MILE POST 7 WEST RIDGE RAILROAD RELOCATION, DAM EXTENSIONS, AND STREAM
MITIGATION PROJECT ENVIRONMENTAL ASSESSMENT WORKSHEET (EAW)

RECORD OF DECISION – FINDING OF FACT 28.h
1975 CASAGRANDE REPORT

FINAL REPORT
ON EVALUATION OF PROPOSED DESIGN
MILEPOST 7 PROJECT

Subject: Final Report on Evaluation of
Proposed Design of Milepost 7 Project

FIG. 14 - PROPOSED CROSS-SECTIONS FOR STARTER DAM NO. 1

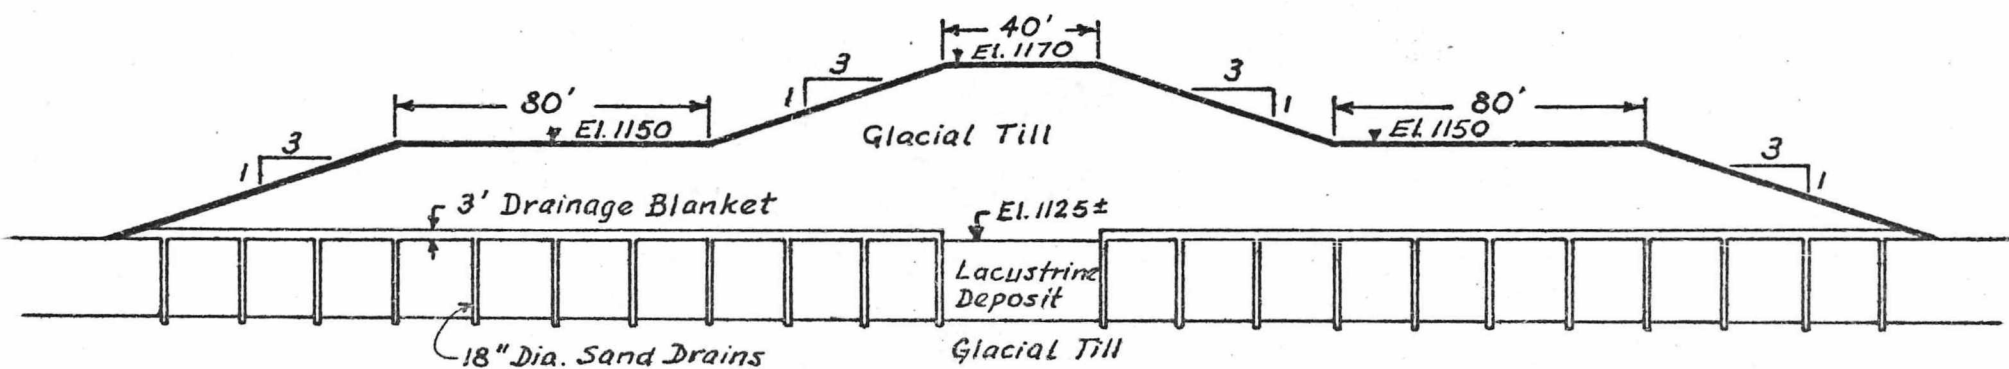
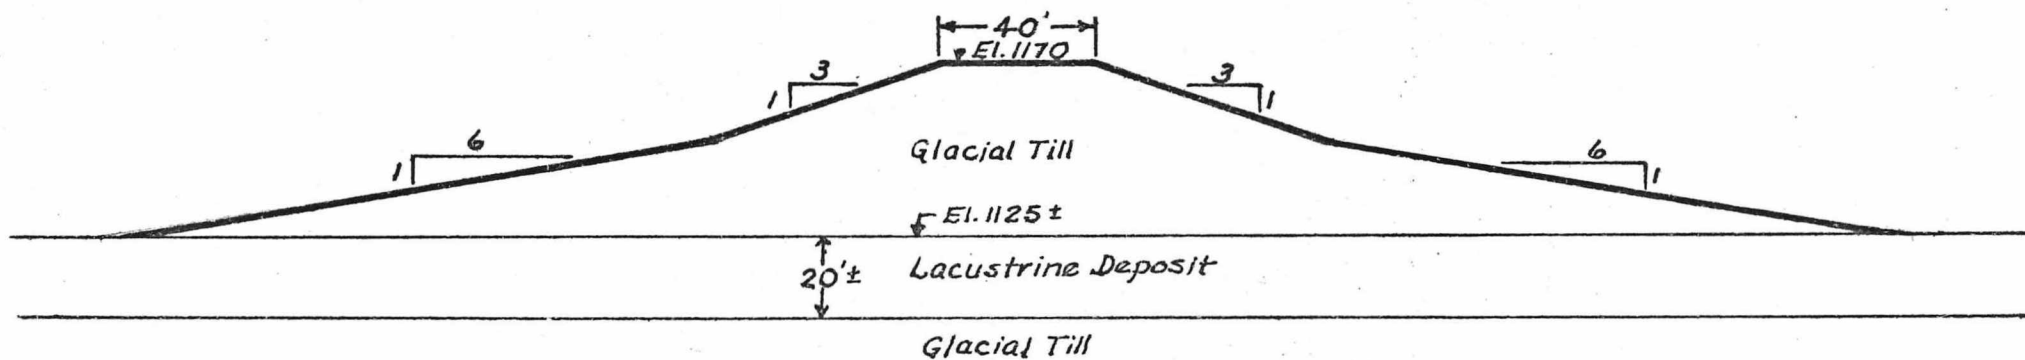
1. The starter dam for Dam No. 1 should be designed without sand drains and without drainage blanket. To improve the stability of this starter dam the berms should be replaced by 1 on 6 slopes, as shown in Fig. 14. Construction of a full-scale test section, including piezometer observations, would provide convincing evidence that sand drains are not necessary.
2. The drainage blanket under Dam No. 1 and Dam No. 2-3 should be 5 ft thick and should extend downstream of the centerline of the main dam, and up to about El. 1200. If it is decided that a drainage blanket is necessary at Dam No. 4 and Dam No. 5, it should be placed under the downstream shell, and up to El. 1225 at Dam No. 4 and El. 1200 at Dam No. 5.
